**ADDENDUM NO. 2**  
**February 10, 2025**

**DLH North Business Development Area Hangar**  
**City Project No. 25-4401**  
**Duluth International Airprt**  
**Duluth, Minnesota**

**SEH No. DULAI 180746**

EXTERIOR ELEVATIONS

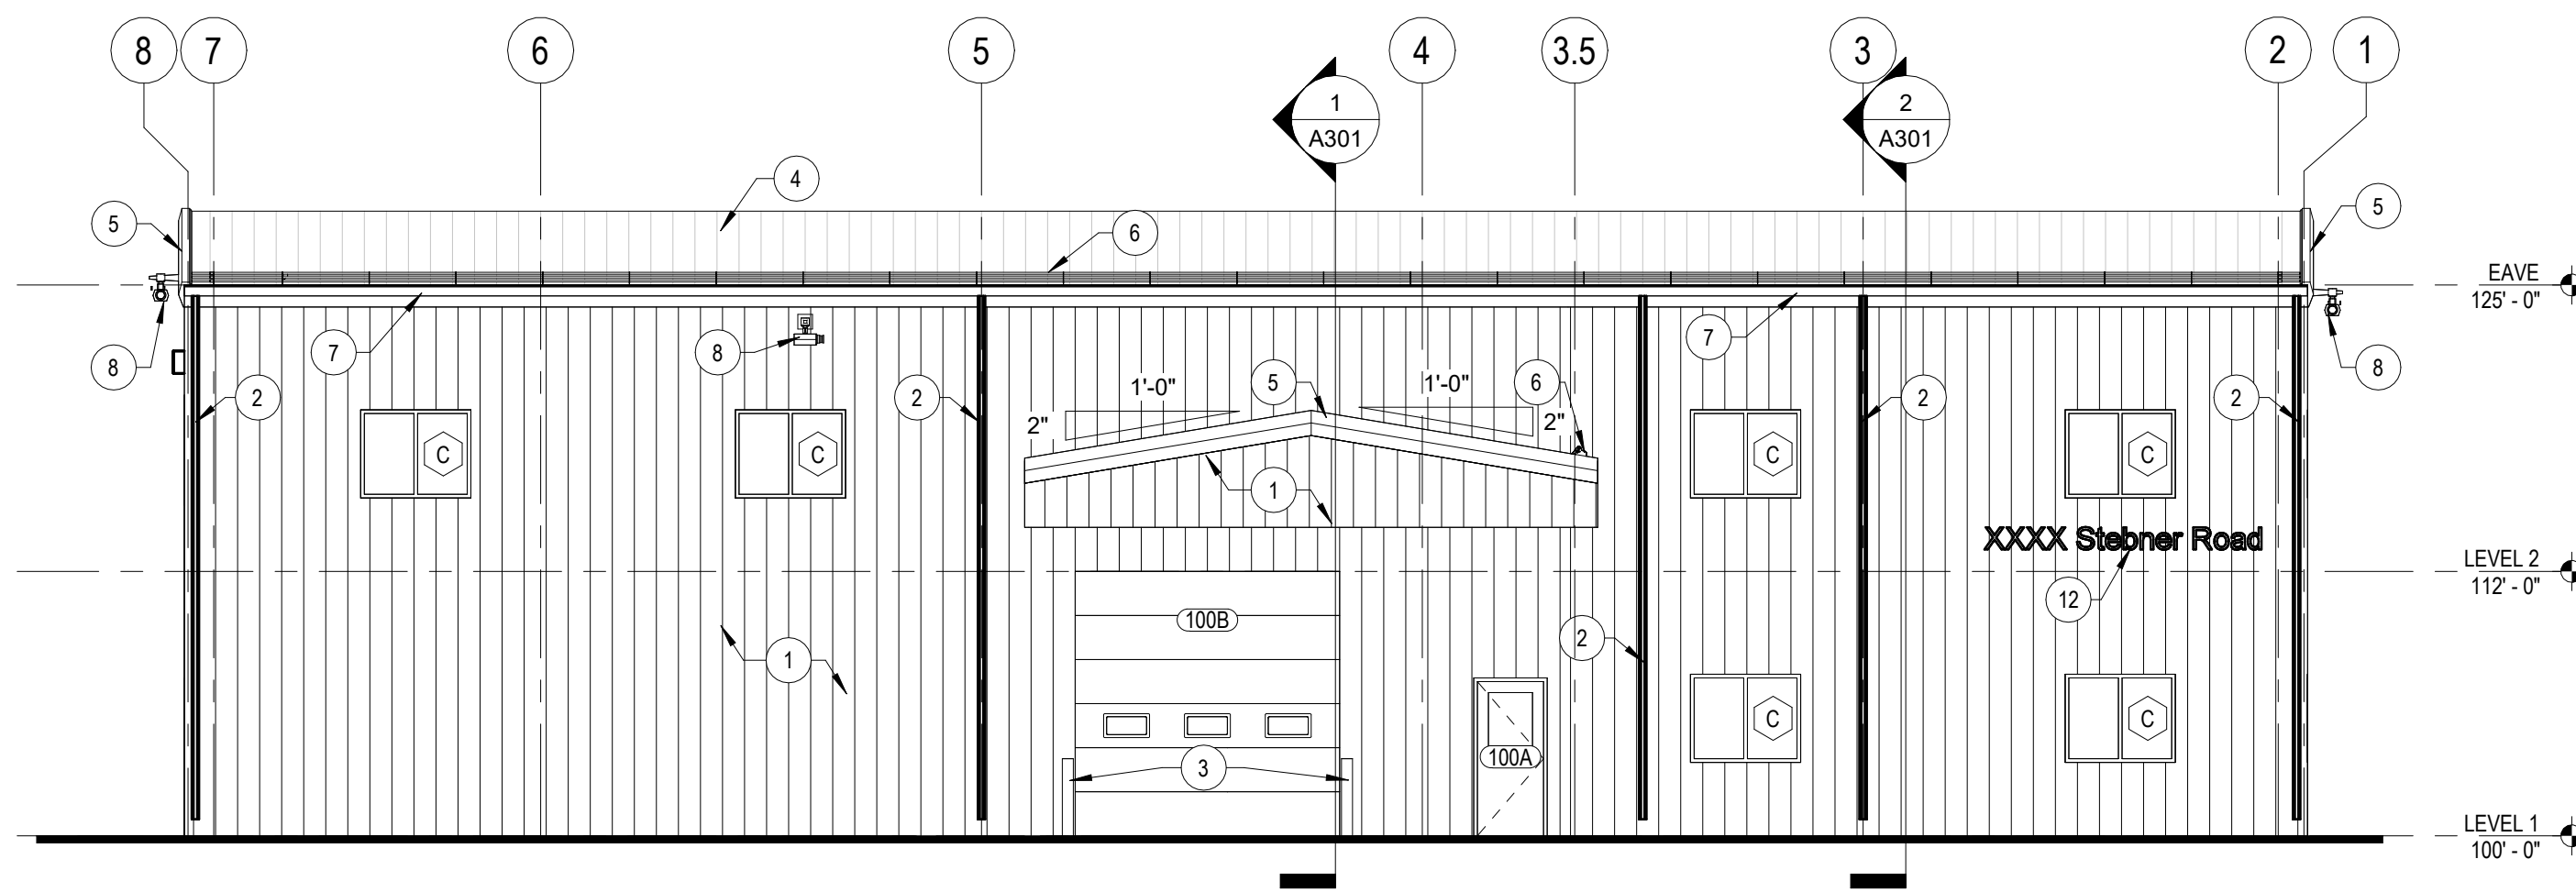
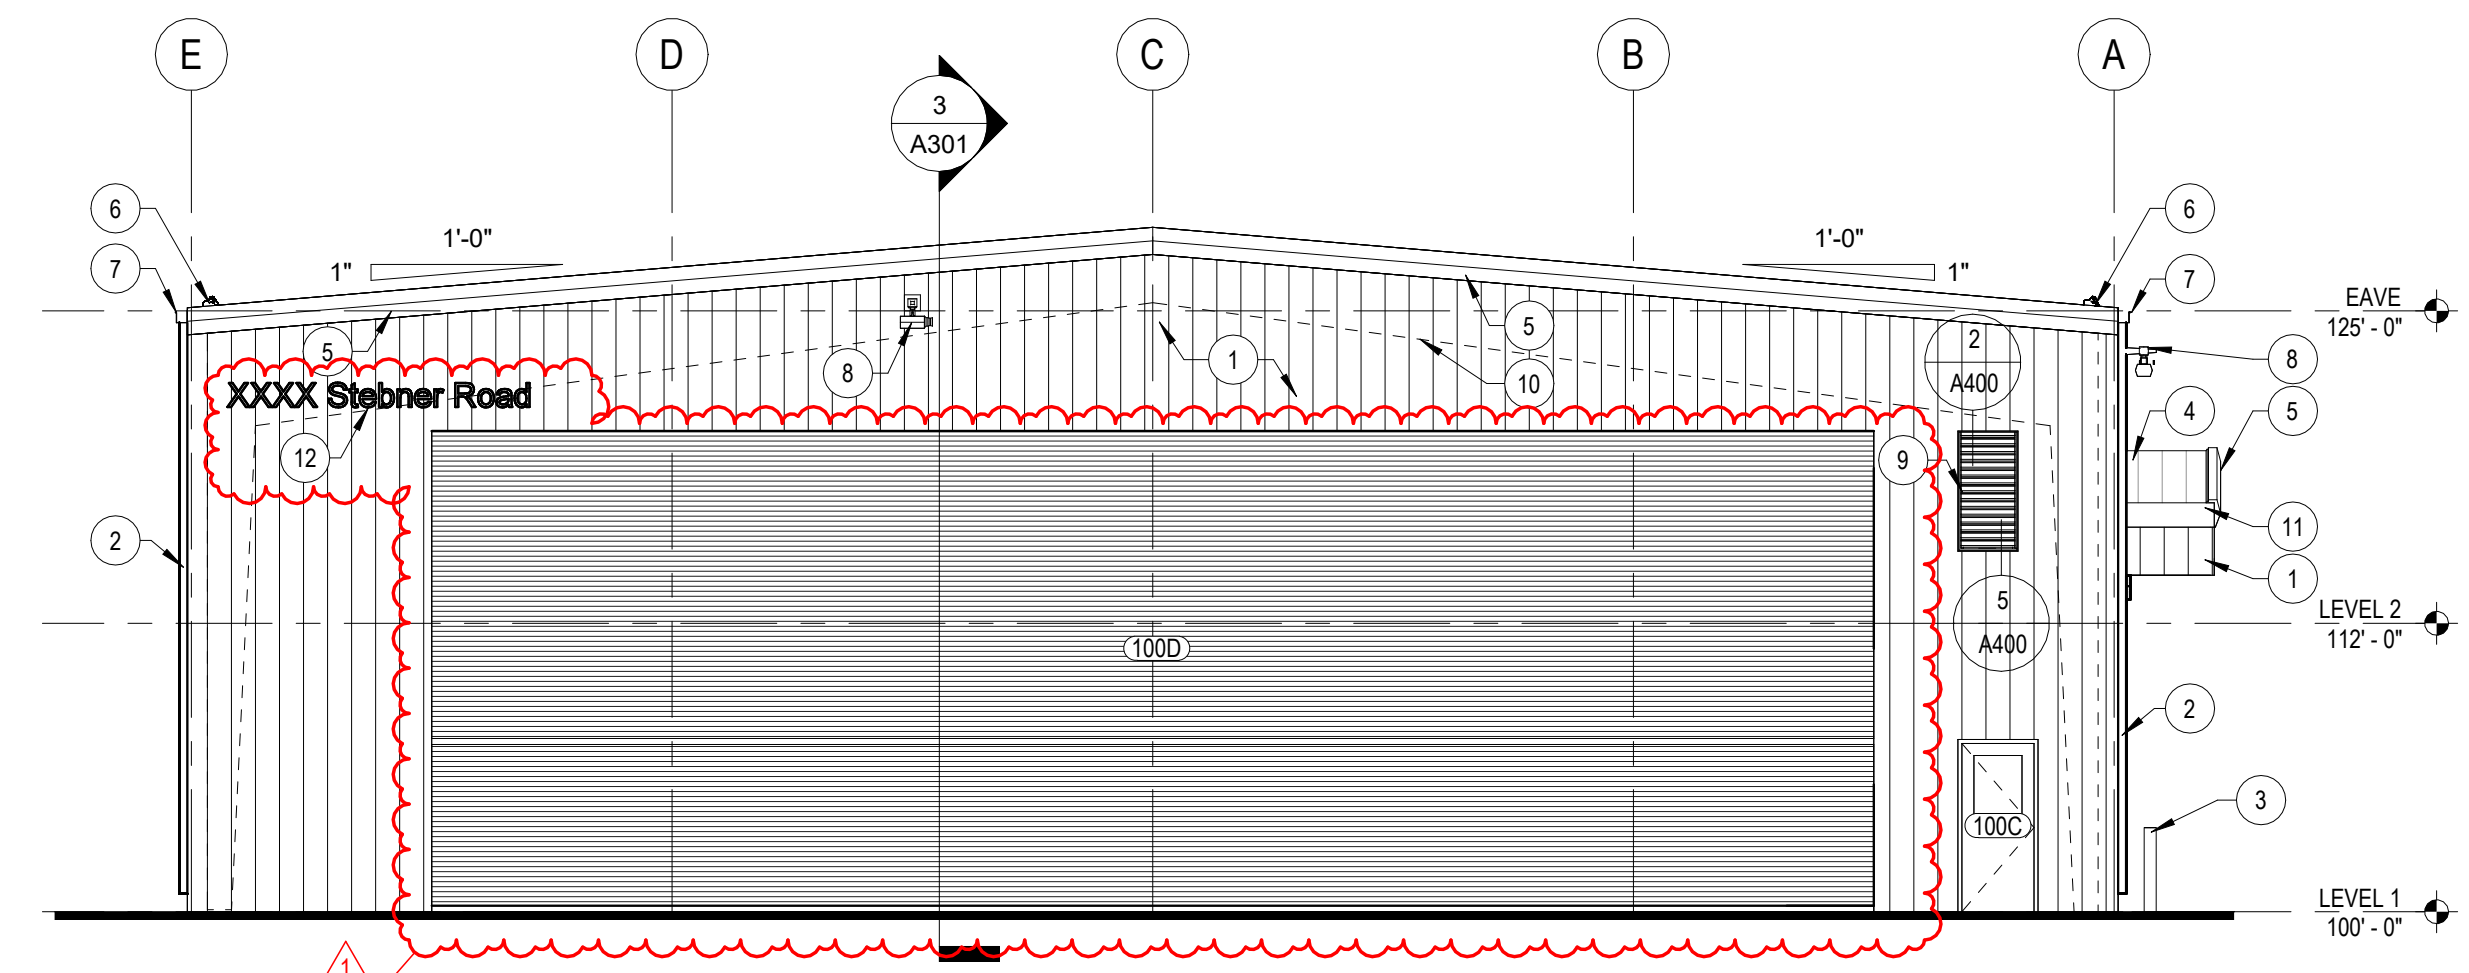
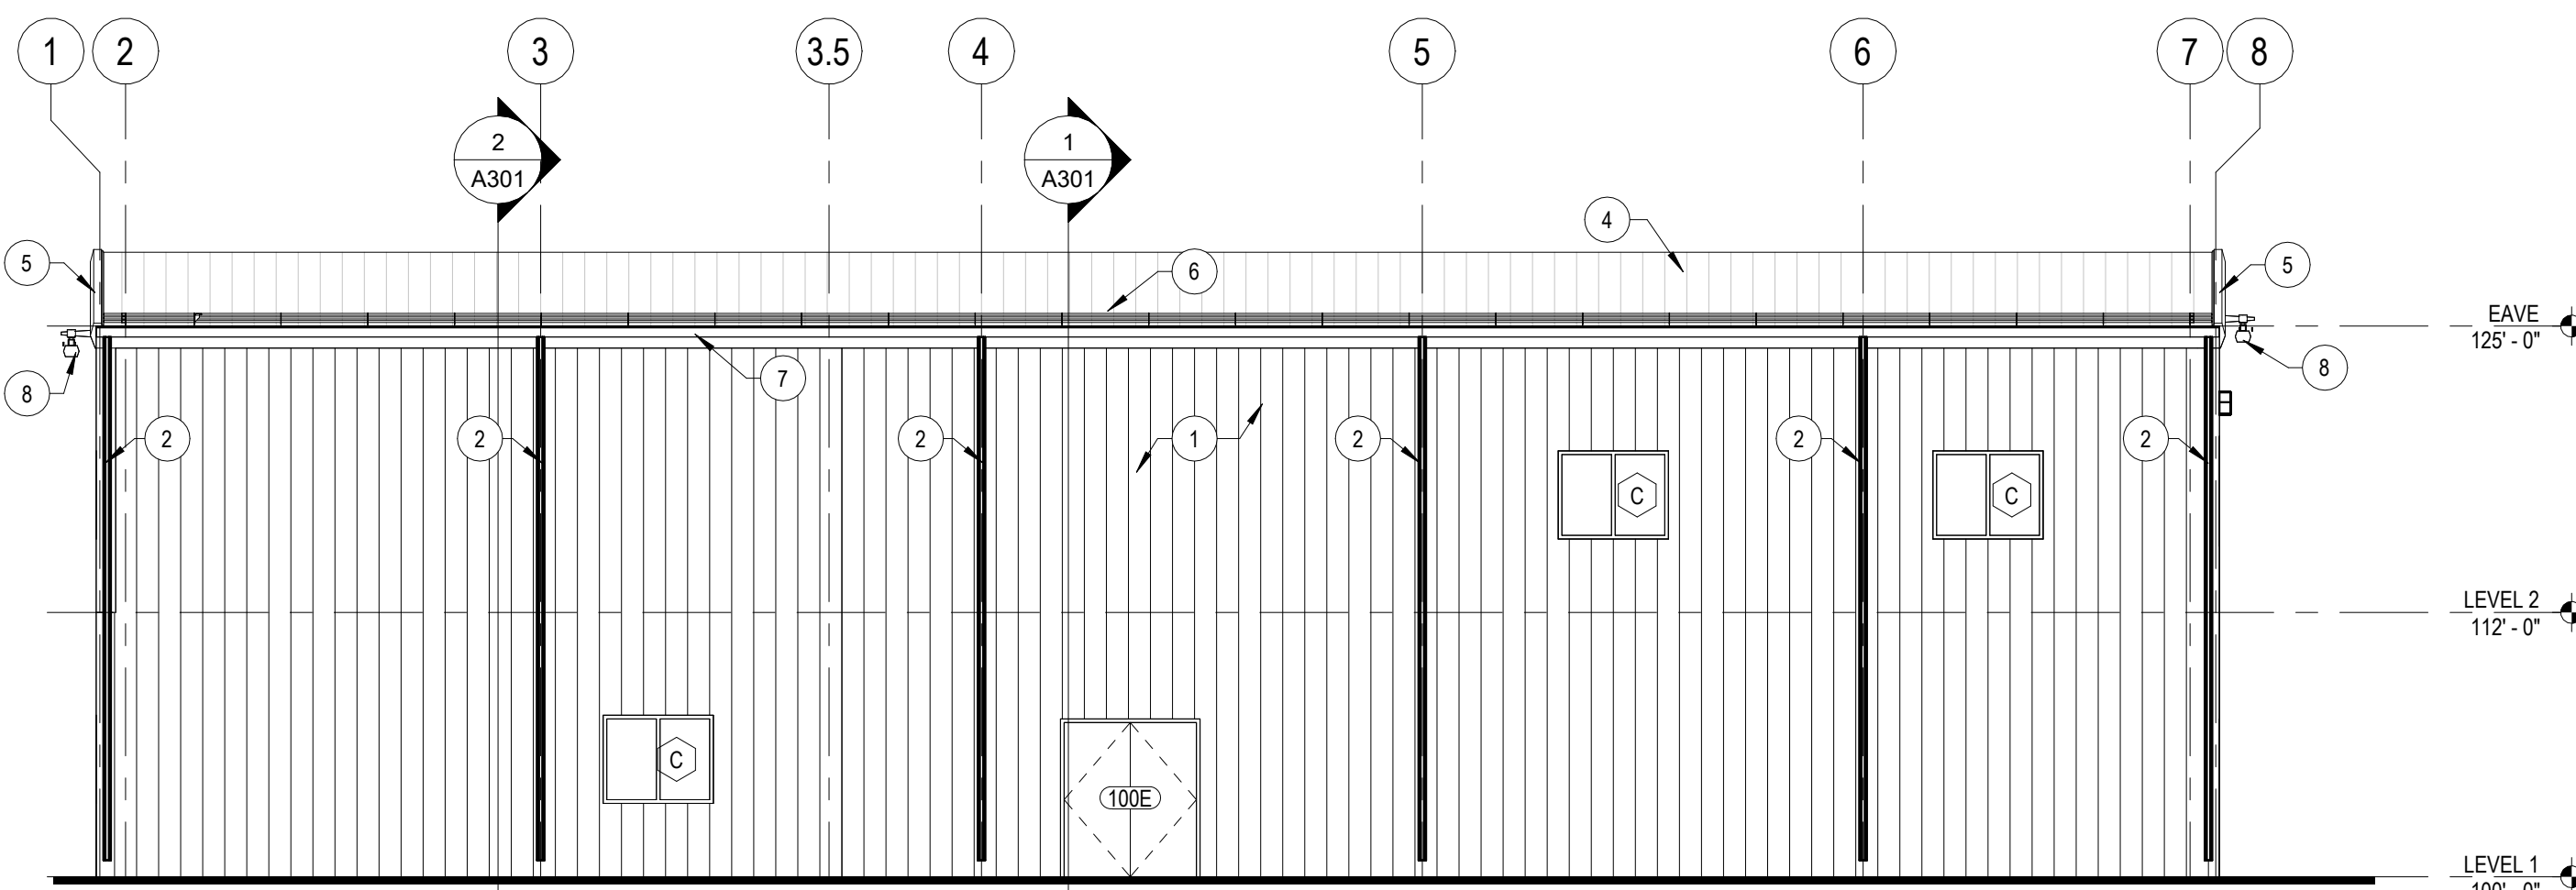
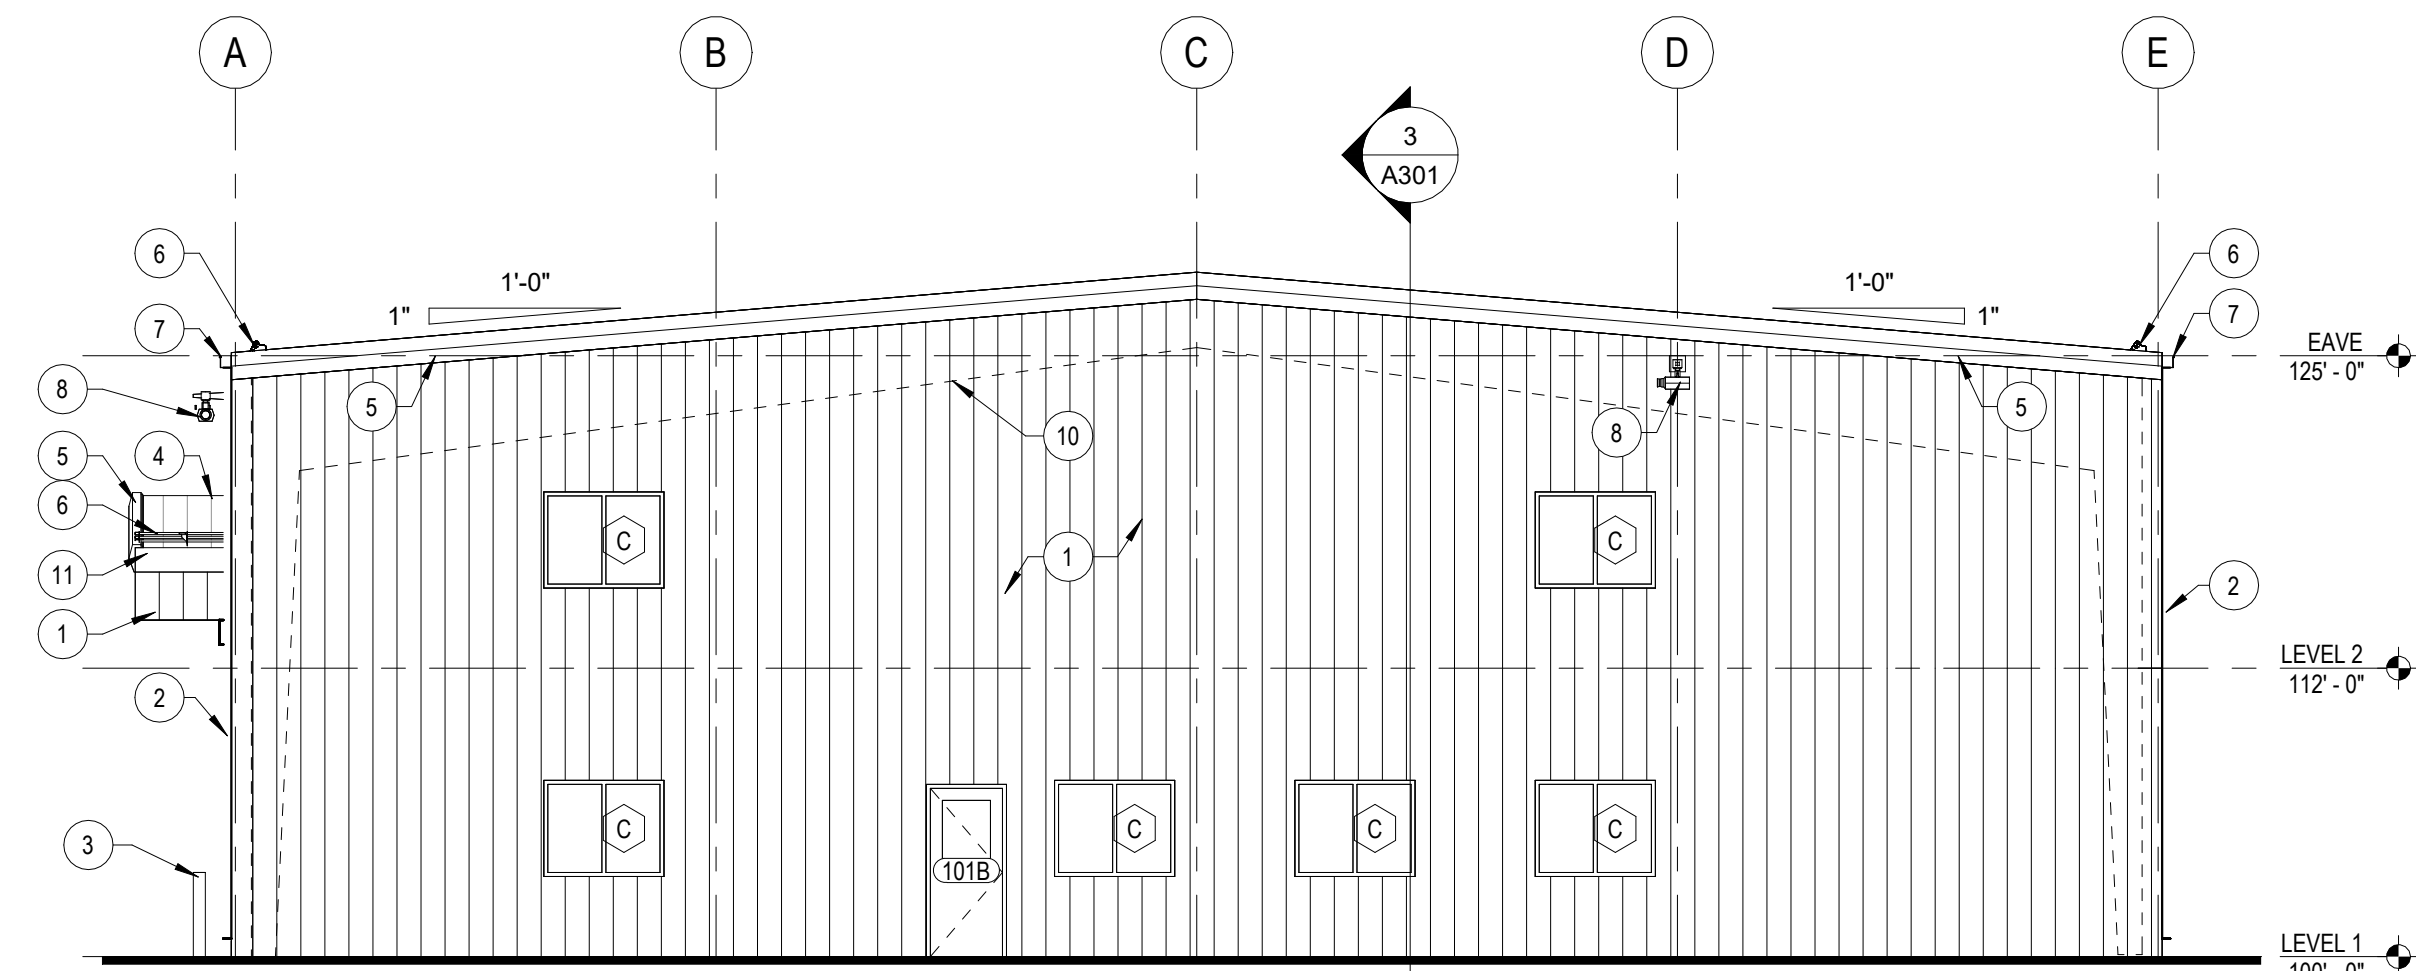
6. Q: I need clarification on the bi-fold door size. Is it 60x16 clear open when the door is open? According to the drawing the architect is showing the top of the door at 16' which would make the bi-fold 13' 6" when open. Please clarify.

*A: See updated attached Architectural sheets. This bi-fold door clearance will need to be 16'.*
